**TO:** St. Francis Planning Commission  
**FROM:** Jason Zimmerman, Consulting Planner  
**SUBJECT:** St. Francis Apartments Concept Review  
**DATE:** 4-10-2025 for 4-16-2025 meeting  
**APPLICANT:** North Shore Development Partners  
**LOCATION:** 3731 Bridge St NW and PID 32-34-24-31-0016  
**COMP PLAN:** Medium Density Residential and Medium/High Density Residential  
**ZONING:** R-2 and R-3

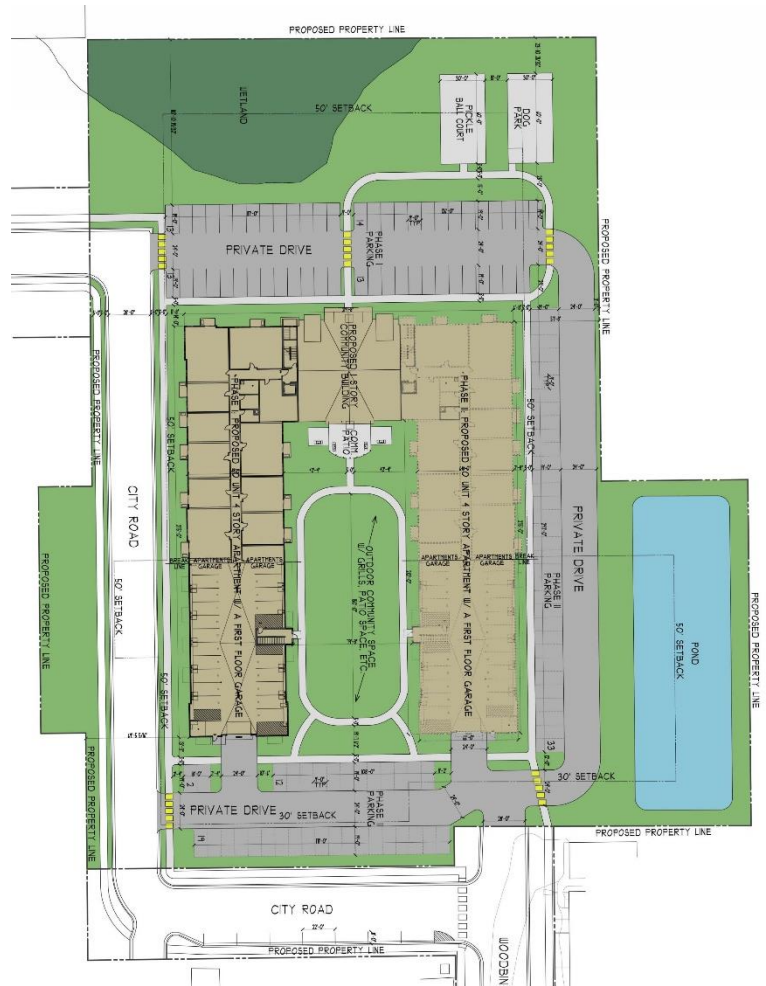
With the inclusion of the new public road, the site would have two front yards (west and south). Each front yard would require a setback of 30 feet. Interior side yard setbacks are 10 feet and the rear yard setback is 25 feet. As shown, the building placement would need to be adjusted in order to meet the front yard setback to the west. A 50 foot setback is required from the R-1 zoned properties to the east; this distance appears to be met.

The property is located north of Bridge St NW. It can currently only be accessed via an unimproved driveway between the Subway restaurant and Milestone Orthodontics. The City owns this land and intends to construct an extension of Woodbine St NW which would wrap around the west side of the apartment property and connect to Ambassador Blvd NW mid-block. Access into the site from this road extension would happen at three locations – one at the northwest corner of the building and the other two at the south end of the property.

The applicant is proposing first floor enclosed parking spaces for each phase of construction (total number of spaces unknown) with 52 phase 1 surface lot spaces and 66 phase 2 surface lot spaces (118 total). Required parking for apartment buildings is based on the type of unit (number of bedrooms). Without floor plans, it cannot be determined if the proposed parking meets the City's requirements. However, at least one space per unit must be enclosed which equates to 120 enclosed parking spaces.

No parking is allowed within 5 feet of a property line. Along the west property line, the parking setback may need to be adjusted.

Sidewalks are shown encircling the building, along the parking lots, and leading to the outdoor amenities. City code requires that sidewalks abutting parking stalls must be 6 feet wide. This dimension should be confirmed as refined plans are prepared.

building divided by 320. Other landscaping standards require a diversity of species. As currently shown, there are long stretches of the parking lot lacking landscaping – parking lot islands with trees should be considered.

Site standards limit impervious coverage to 50% of the area. When the second phase of the building and additional parking lots are constructed, this threshold may be surpassed.
